BUTLER AVE IMPROVEMENTS

FLAGSTAFF, AZ

MARCH 2026

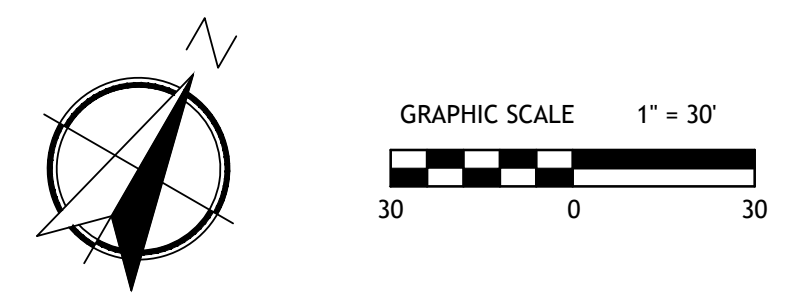
the turn lane doesn't seem needed west of Sinagua Heights, I recommend having it raised (an extension of the Butler/4th project cross section). This could be a phased add-on if the funding isn't there initially.

show a 2' buffer/furnishing strip where we don't have the full parkway (typ.), or else I worry this feature will get overlooked, it will be easier to cut this out where it really doesn't fit than sneak it into a scope that never anticipated it.

raised median here, where no turns, and to create side friction as this hill starts to hopefully calm traffic a little more.

~3.7% slope, especially if we get a median here, this could be a better candidate for an enhanced crossing (serves peds coming/going west to Sinagua and peds going between schools). PROWAG discusses cross slopes up to 5% when that matches the main road. The other issue is stopping/starting approaches if signalized. If just a flashing beacon, would be able to get up to 5% slopes. Would have to further evaluate just a flashing beacon unless we can get down to one lane in each direction and a median refuge in the center though.

20' clear (if that is goal here for fire) can be to face of curb.

Is this stop bar too far back, will cars all pull forward and block the bikeway/crossing?

trying to think through the grading here, we catch existing road at a higher grade since there is less cross-slope distance, so likely we can tie-into Fire Station driveway further back, show sidewalk further back with note to match grade vs. at ROW so later iterations can max-out what works for grading vs. thinking we are tied to ROW somehow. Bigger picture, is it worth evaluating chasing pavement to centerline and adjusting cross slope to get us even more sidewalk width? 0.5%, basically sheet flow with adequate longitudinal slope that eventually finds the gutter? or full superelevation to south, FUTS by car wash could benefit from being higher too.

as witnessed, there is demand for two-way wheeled travel between sinagua and foxglen, what are the group's thoughts on making this more of a mixing zone vs. one-way bikeway? can we get another foot + of parkway and plant trees, even if not everywhere, would we need another foot of path width? Me, and adjacently-backed by AASHTO bike guide would prioritize parkway width since 11' vs. 12' path doesn't make huge gains on LOS.

evaluate more of a two-way mixing zone here, like existing, vs. one-way bike

what about MAG 250 style vs pork chop, to narrow the crossing and keep FUTS above street grade?

wrap wide sidewalk up Fox Glenn St to bike lanes, then provide bike ramps to/from on-street bike lanes.

what are benefits for a more typical ramp placement to have peds/bikes wait at sidewalk level?

SECTION D

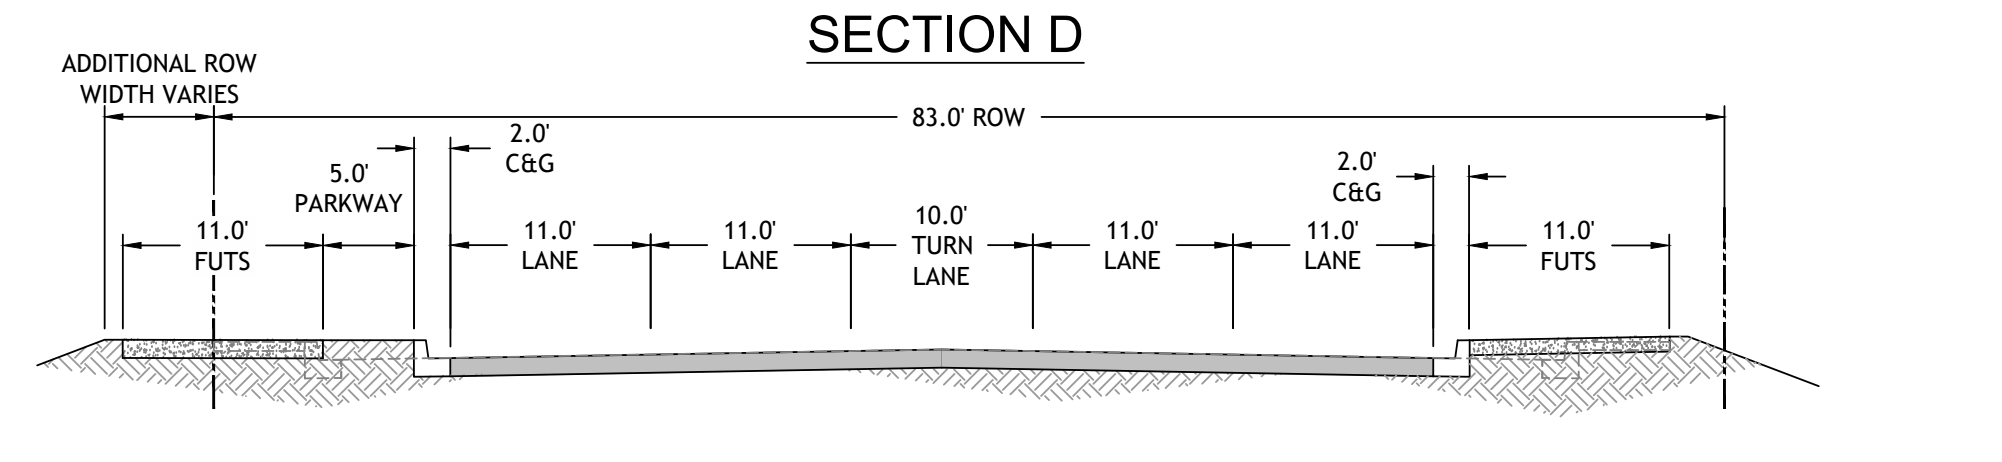
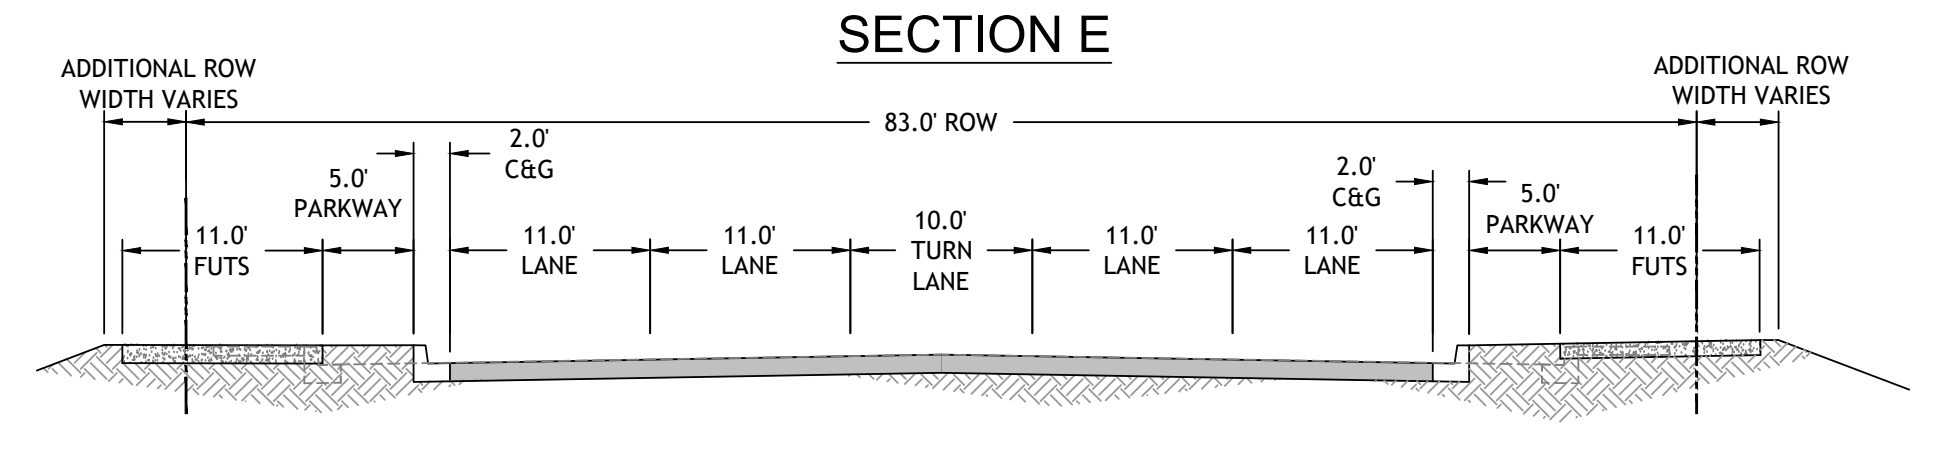
since we are leaving existing ROW and chasing grading anyway, a little bit more parkway could go a long ways. I recommend 8' (but even 6' vs. 5' will help). this can support more landscaping and create a more physical buffer (similar to further east). I also think this segment (and existing segment further east) should be set-up to carry two-way rolling traffic and having a different parkway can help signal this change of facility type (a two-way FUTS vs. a one-way separated bikeway). And evaluate matching the width of the existing 12' FUTS to help signal that this is an extension of that and expectation that it will be busier and two-way.
